RE: St. Lucie Units 1 and 2
Docket Nos. 50-335 and 50-389
Supplemental Information to
Spent Fuel Pool Cask Pit Rack Amendments

SPENT FUEL STORAGE EXPANSION

ST. LUCIE UNITS 1 AND 2

FLORIDA POWER & LIGHT

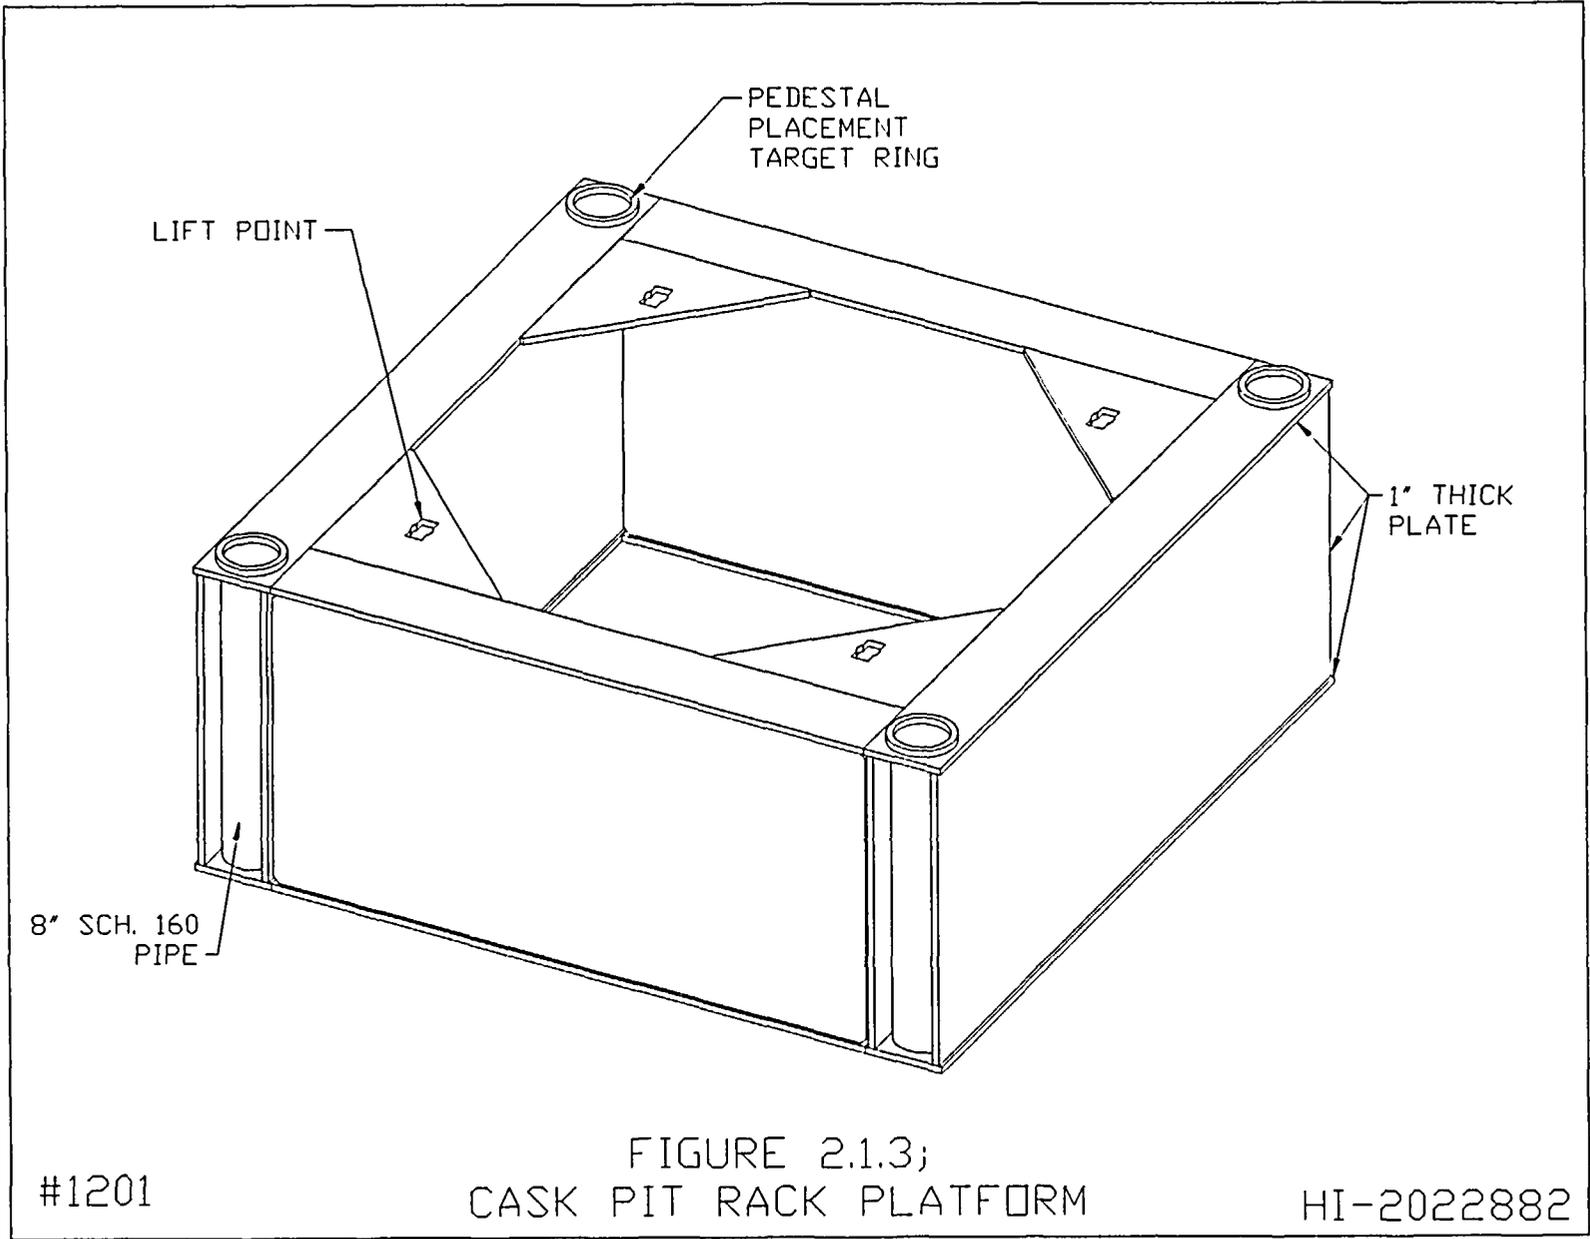
Corrected reference numbers on the following pages 4-3, 4-4, 4-16, 4-17, 4-18, 6-35, 8-15. Adjusted fuel rod diameter tolerance for CE fuel in Table 4.1.4.1. Revised fuel weight discussion in Section 6.3.1. Removed proprietary designation from footer of Appendix 4A. Corrected baseplate hole diameter on pages 2-12, 2-15, and 2-16. Corrected cell inside dimension on page 2-15. Revised proprietary information highlighting designation on pages 6-23 and 6-24. Adjusted text on pages 2-14, 2-15, 2-16, 3-5, 5-22, 6-31, 6-32, 6-34, 7-1, 7-2, 7-5, 7-8, and 8-1 to address revised rack cell and platform heights and weights. Corrected Figure 2.1.3 to reflect revised rack platform lift point configuration.
